- Request - Special Use Permit for Community Recreation (Active)
- Location - 617 City Park Avenue
- Owner - City of Toledo
One Government Center
Suite 2250
Toledo, OH 43604
- Architect - Thomas Porter Architects
8 N St. Clair Street
Toledo, OH 43604

The staff recommends that the Toledo City Plan Commission recommend approval of SUP26-0014, a Special Use Permit for Community Recreation (active) at 617 City Park Avenue, to the Toledo City Council, for the following two (2) reasons:

SPECIAL USE PERMIT
TOLEDO CITY PLAN COMMISSION
REF: SUP26-0014
DATE: April 9, 2026
TIME: 2:00 P.M.

OVERALL LAYOUT PLAN

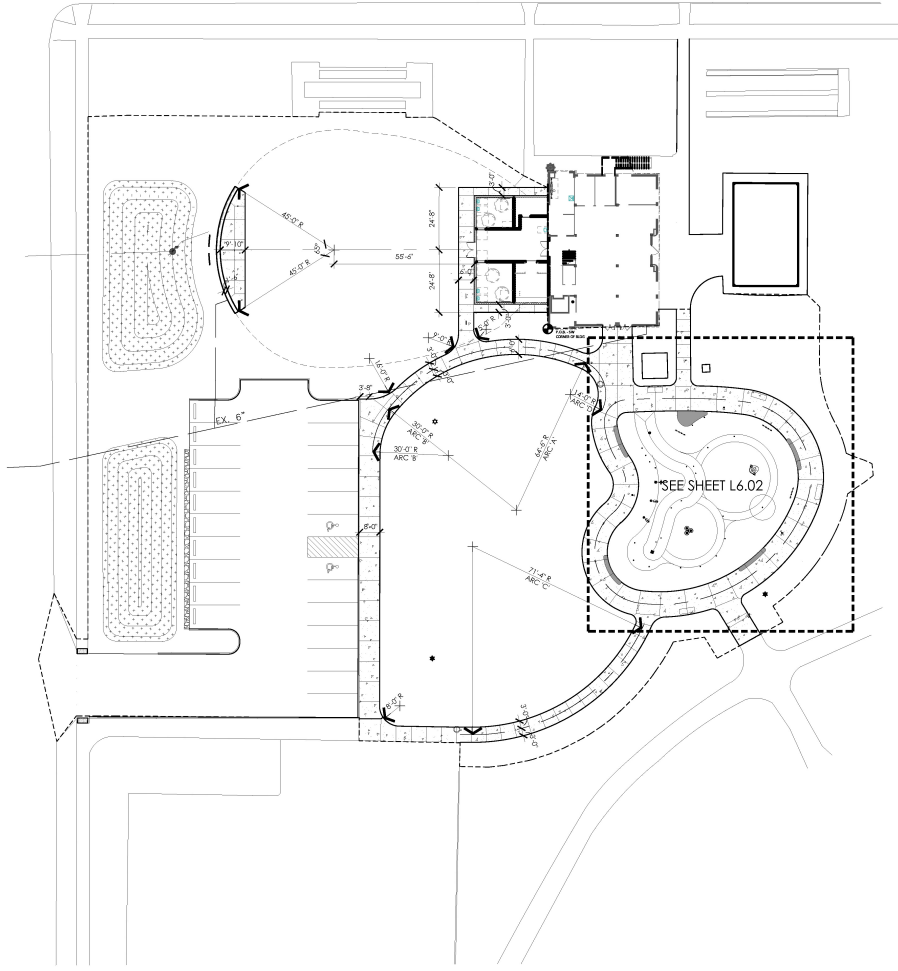
18. Per TMC§1107.1911, parking spaces laid out at a 90-degree angle shall have a width of at least nine feet (9'). **Not acceptable as depicted. A revised site plan with parking spaces nine feet (9') in width.**

19. Bicycle parking slots shall be provided pursuant to Off-Street Parking Schedule "A" (TMC§1107.0300). One bicycle parking slot shall be provided per every ten (10) parking spaces for a total of at least three (3) spots. **Not acceptable as depicted.**

LANDSCAPE PLAN

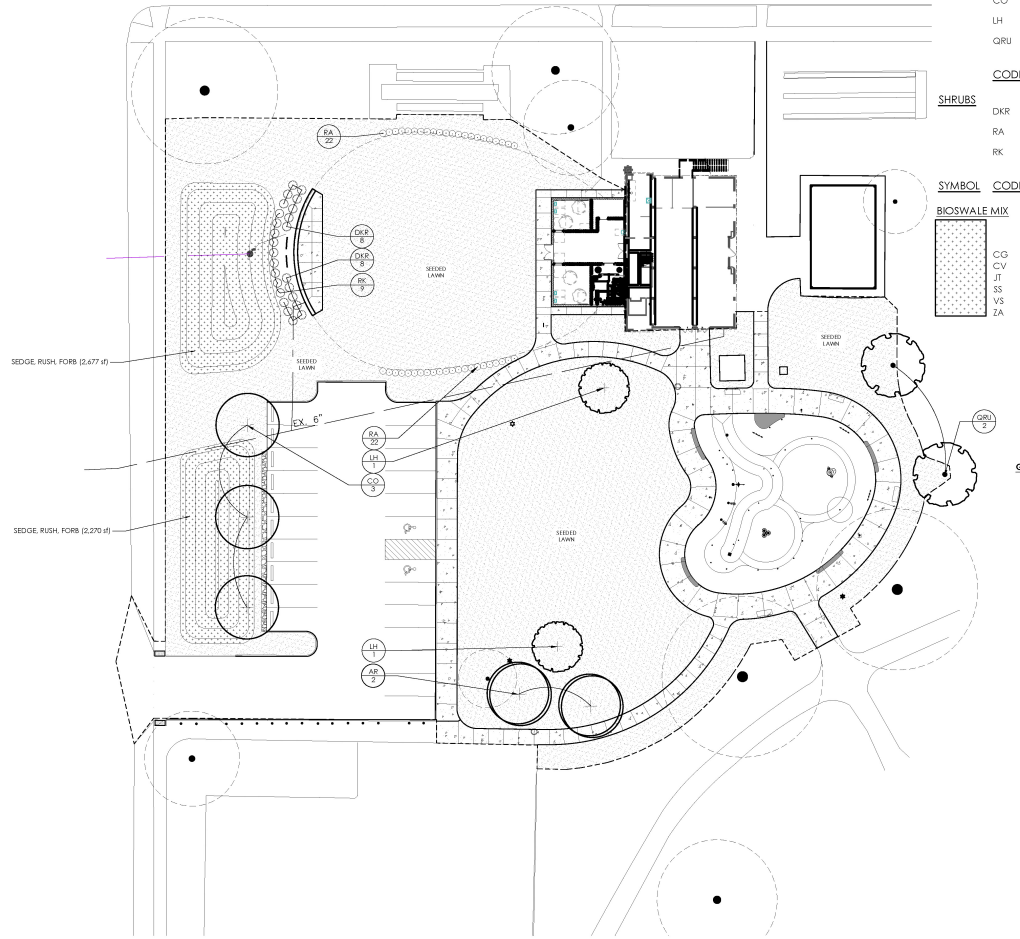
- b. Perimeter landscaping must be installed along any parking lot area adjacent to a street, place, or driveway, or which is visible from an immediately adjacent property, and must include a continuous shrub row with a minimum height eighteen inches (18") to screen headlights. **Not acceptable as depicted. A revised landscape plan with a shrub row facing Elizabeth Street is required.**

DRAWING TITLE:
PROPOSED ELEVATIONS & ENVELOPE

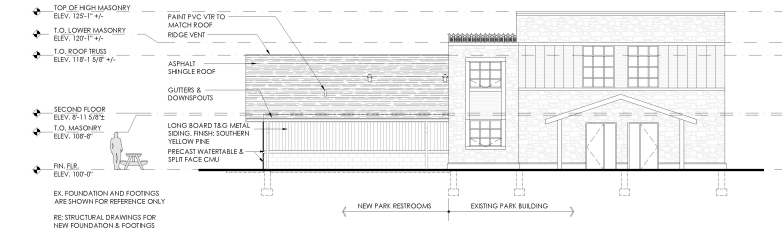
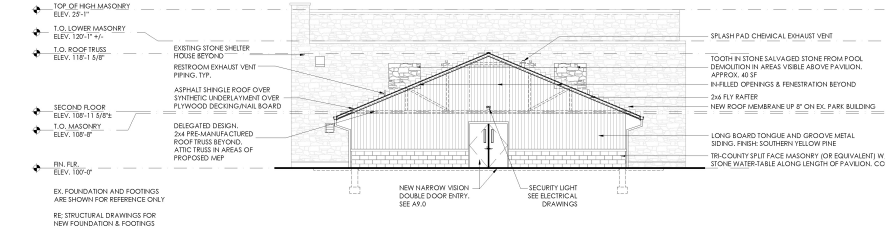
Elevation drawings were submitted for an addition to the existing building at the park. The 1,100 square foot addition will house restrooms and a room for mechanical equipment. Building materials proposed include metal siding designed to look like wood, split face CMU, and split face masonry along the base of the western elevation. Per TMC§1109.0500, building material standards apply to all facades that are visible from the right-of-way. Revised elevations showing the percentage breakdown of each building material. Additionally, proposed elevations do not meet the material standards. Architectural metal shall be smooth flat or flat embossed. Striations, planking, ribbing, or variations in height or depth are discouraged. The material is intended to look like wood planking, which is subject to Planning Director approval. Applicant shall provide material specifications to ensure the material meets the intent of the code.
